RE: FCC: Y3J-DCCI-BT
IC: 9409A-DCCIBT

David Clark Company Inc., hereby declares that all production units of our Model DC ONE-X Aviation Communications Headset have incorporated the modifications defined in Test Report 511-15 Issued 2/12/16, on page 3 in section 2.8 titled EMC Modifications. Specifically we have incorporated the pi filter in series with the Bluetooth antenna, (ANT1):

This is shown on Page 3 (of 10) on our In-Line PCBA Schematic, 43000G-17EL-MAS Rev D. The specific portion of that circuit is pasted below:

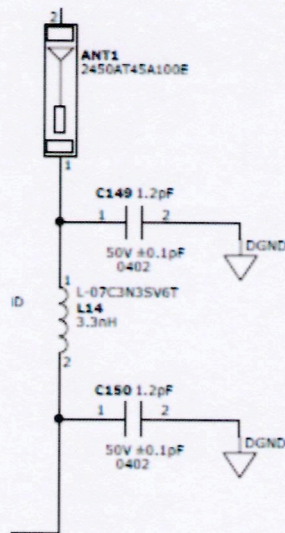
- Shunt 1.2 pF (C150)
- Series 3.3 nH (L14)
- Shunt 1.2 pF (C149)
